The response from the FAA to the safety recommendation

The Japan Transport Safety Board received the response from the Federal Aviation Administration (FAA) of the United States of America to the safety recommendation issued September 25, 2014 as attached regarding a Serious Incident of JA16AN (Boeing 737-700) operated by Air Nippon Co., Ltd. at an altitude of 41,000ft about 69 nm east of Kushimoto, Japan on September 6, 2011.

SUBJ: Flight Controls

SAIB: NM-15-03

Figure 1 – Rudder Trim Switch

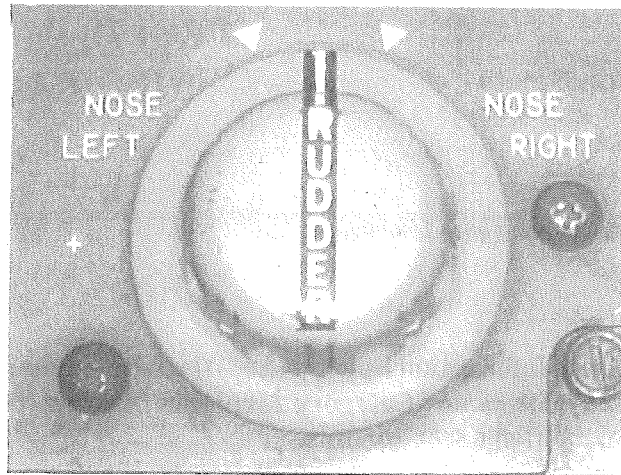
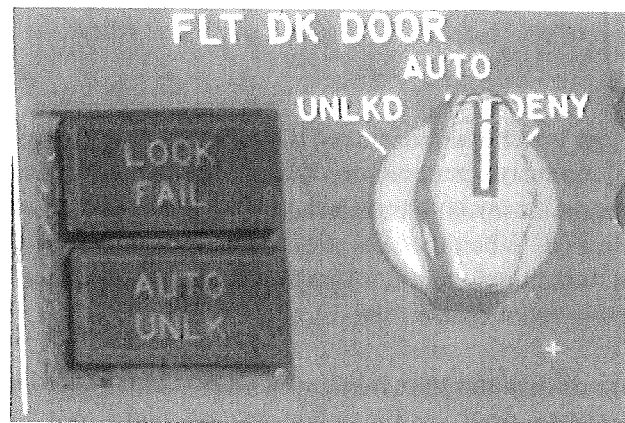
During the investigation of this incident, numerous aisle stand configurations were identified due to the multitude of supplemental type certificate installations and significant variability in the Boeing-delivered configurations. On the incident airplane (Model 737-700), the rudder trim switch is in approximately the same location as the flight deck door control switch on the operator's Model 737-500 airplane. This creates a potential for confusion when pilots transition between aircraft. Positive training on one model can become negative when the pilot transfers to a different model. Although the rudder trim switch (Figure 1) and flight deck door control switch (Figure 2) are different in size and shape (cylindrical vs. blade shaped), and the flight deck door unlock side of the switch must be depressed before turning, the general feel (spring force) to actuate the switches is similar; both are spring loaded to the center position. In this incident, the negative transfer error allowed the pilot to think he had operated the correct control, and the similarity of the control's operation exacerbated the situation.

Having a consistent position for the rudder trim switch is paramount because it provides a direct input to the aircraft rudder and can induce both yaw and roll into the aircraft flight attitude. Because both the rudder trim switch and the flight deck door control switch have a similar feel and action (turn and hold), a standard location and sufficient separation between these controls is recommended. Placing the controls in the recommended locations is consistent with most Boeing-delivered airplanes and creates a distinctive reach posture, provides sufficient separation in relation to reach direction from both seats, and provides adjacent tactile landmarks. This includes the railing in the corner of the aisle stand and the guarded stabilizer trim switch located between the rudder trim switch and the flight

1. Place the rudder trim switch in the center column as far aft as possible.
2. Place the flight deck door control switch in the far right column (first officer side) aft position.
3. Do not place the flight deck door control switch in the center column.
